Accessibility Survey

City of Downey Clancey Avenue - Cecilia Street to Baysinger Street

Date of Inspection 6/12/2017

Disability Access Consultants

Sidewalks : No Sidewalk

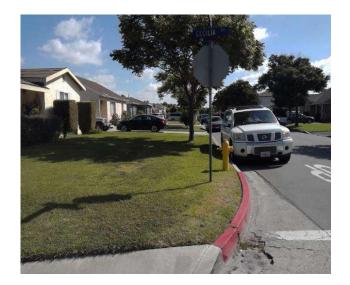
No sidewalk exists at the location.

On-Site Finding Not Found

No action necessary until a sidewalk is provided.
